Seaside Park and Community Arts Center

DRAFT-~~FINAL~~ SCOPE OF WORK FOR AN ENVIRONMENTAL IMPACT STATEMENT

CEQR NO. 13DME014K

Response to Comments on the Draft Scope of Work for Seaside Park and Community Arts Center

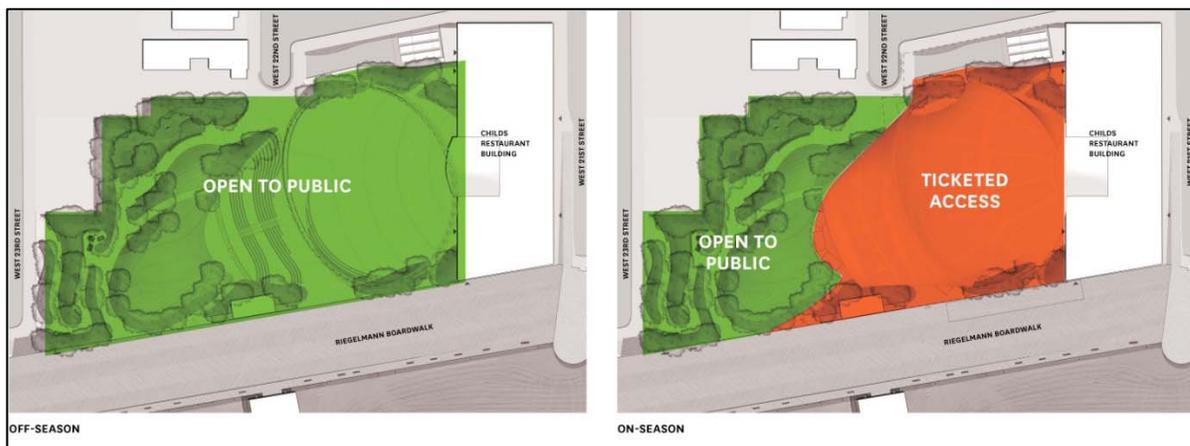
Comment 3.6: The plan refers to open space and is basically saying that the amphitheater will serve the function of open space for the community. How accessible will that open space actually be to the community? How many months out of the year will that be? (19)

Response: During the summer months (approximately May to October), it is anticipated that the proposed amphitheater would host approximately 30 to 35 paid concert events and 10 to 15 free concert events on both weekdays and weekends. The amphitheater would be publicly accessible year round, with the exception of when a ticketed event is in progress.

During the concert season between May and October, which coincides with the season for operation of Coney Island’s amusement rides and attractions that generally extends from Easter Sunday to Halloween, the tensile roof would be installed. At the time of seasonal event operations, when concerts and other events involving the amphitheater are scheduled, seats would be placed in the plaza. During concerts, the proposed amphitheater would also have additional noise reduction features, including a deployable tensile canopy extension and acoustical curtains. For the free Seaside Summer Concert Series performances the public would have open access to the entire development site and the concerts also could be viewed from the Riegelmann Boardwalk and the areas of the development site west of the plaza and stepped seating. At the time of paid concerts and other paid events, a temporary fence would be installed surrounding the perimeter of the

amphitheater, which would limit physical and visual access to concert patrons with paid tickets (refer to illustrative figure below).
